# Access Compliance Report

## Public Rights-of-Way

Intersection ID: 46932	Main Street: IDLEWILD_RD_NORTH	Cross Street: SYCAMORE_GROVE_CT	Location: SE
ADA ID: 258BC2554072	Ramp Type: PerpDiag	Initial Pass/Fail: Fail	Overall Compliance: No
Severity Score: 21.25			
Codes/Mitigation Info/Possible Solution		Field Measurements/Component Compliance

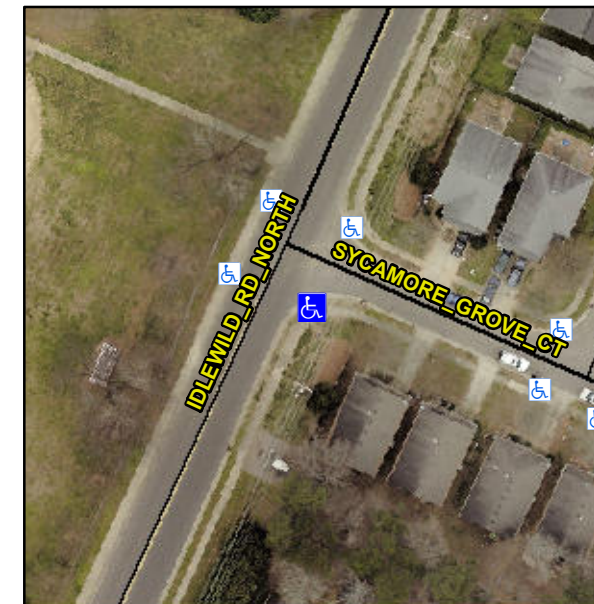
**Not Found, R304.5.1, R304.2.2**

Compliance	Description	Data	Compliance	Description	Data
N/A	Ramp Length (in)	47.5	No	Ramp Slope (%)	10.9
No	Ramp Width (in)	43.0	Yes	Ramp XSlope (%)	0.8
N/A	Flare Type LT	N/A	N/A	Flare Type RT	N/A
N/A	Flare Slope LT (%)	N/A	N/A	Flare Slope RT (%)	N/A
N/A	Flare Traversable LT?	N/A	N/A	Flare Traversable RT?	N/A
N/A	Landing Length (in)	N/A	N/A	DWS Provided?	N/A
N/A	Landing Width (in)	N/A	N/A	DWS Contrast?	N/A
N/A	Landing Slope (%)	N/A	N/A	DWS Length (in)	N/A
N/A	Landing X Slope (%)	N/A	N/A	DWS Full Width?	N/A
N/A	Landing Curb? (Y/N)	N/A	N/A	DWS Offset (in)	N/A
N/A	Shared Landing?	N/A			
N/A	Gutter Ponding?	N/A	N/A	Gutter Slope (%)	N/A
N/A	Gutter Lip Ht (in)	N/A	N/A	Gutter X Slope (%)	N/A
N/A	Painted X Walk1?	No	N/A	Painted X Walk2?	No
	X Walk 1 Direction	To NE		X Walk 2 Direction	To NW
N/A	X Walk 1 Width (in)	N/A	N/A	X Walk 2 Width (in)	N/A
	X Walk 1 Slope (%)	1.1		X Walk 2 Slope (%)	0.0
	X Walk 1 X Slope (%)	1.1		X Walk 2 X Slope (%)	0.0

**Remove & Replace Curb Ramp With Two New Directional Ramps or Equivalent.**
